Urban Design Review Panel Comments

2024 November 26

Urban Design Review Panel Comments – Applicant Response

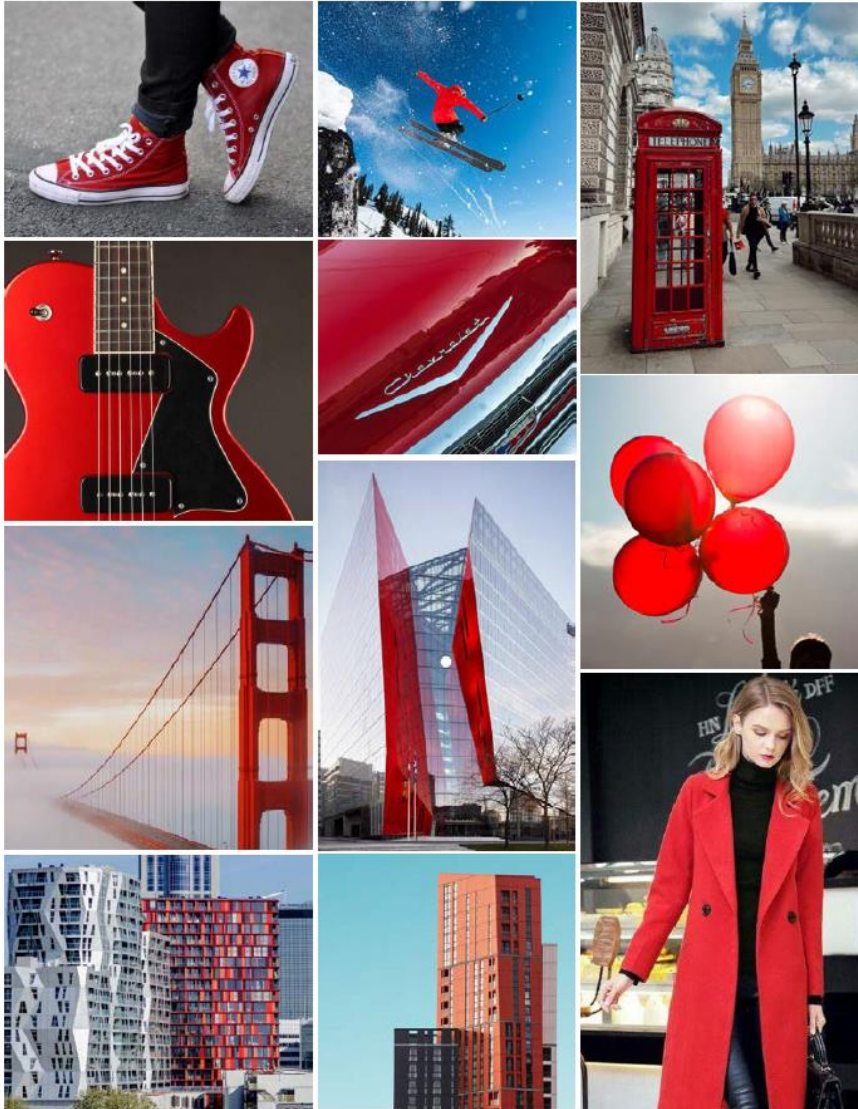
Colour: We understand that there were concerns from the UDRP panel about the colour choices presented for the tower and podium materials. A polarizing subject, there is no doubt. The design expression for the Plaza 54 tower is to create a mixed-use residential tower that has an identity. Our client has asked GEC to design a building that will stand out from the other residential towers that have been recently constructed within the Beltline, the East Village and the existing fabric in Eau Claire. Each of the buildings we reviewed have a different colour combination and architectural expression that helps them stand out amongst their competitors. The colour choices we've made, along with the architectural expression have been intentional to achieve this vision. The two primary materials for the tower are clear glass and black glass spandrel panel. Plaza 54 will stand within the cityscape as a bold and contrasting tower, standing out from the neighbouring towers. It will add to the variety, texture and interest of the skyline.

Black presents a modern and contemporary style that has a lasting quality. It matches the vision that our client has for the project and will suit the marketing that they will pursue for the project. We have completed many high-rise towers using black as a primary colour for the spandrel panels. We know very well what the outcome will be and have confidence in this direction. We have been very deliberate in making sure that the black is achieved through a back painted spandrel glass panel over a prefinished metal panel. Our experience has found that this approach helps to resist fading and keeps the tower looking clean and modern throughout the seasons and over time. A metaphor that we have often used when discussing black as a colour for buildings is a tuxedo. Over time, there are many details that have evolved and refined to match the styling of the day, but the colour has remained (see images below).

Through our design process for the Plaza 54 project, we spent lots of time and effort looking for a complimentary colour that we could use to work with the black in a way that would suit the design direction, be contemporary, and be unique. The more we looked and tried different options, the more that red came up as a suitable decision.

Red draws attention creates a focal point and adds a dynamic edge to the tower. We've used the colour as an accent on the north and south elevations, in a fading linear pattern, to accentuate the verticality of the tower. Since we presented the design to the UDRP, we've adjusted the colour from a darker, deeper red, to a brighter more vibrant red. We have also revised the material choice from prefinished metal panel to a back painted glass spandrel.

We understand that there was some concern from the UDRP that the decision was simply made as a result to the coincidence that several corporations in Calgary use red for their corporate branding, but we can assure you that the design intent was not simply that. Red is a colour that has been used in the Calgary skyline to highlight important landmarks such as the Calgary tower, the Peach Bridge and the Saddle dome. Red has is used throughout fashion, graphic design, and vehicles, to stand out amongst the crowd. We feel very strongly that the colours chosen for plaza 54 will create a striking unique tower within the skyline. It will be a building that will add some much-needed presence to that section of the skyline.
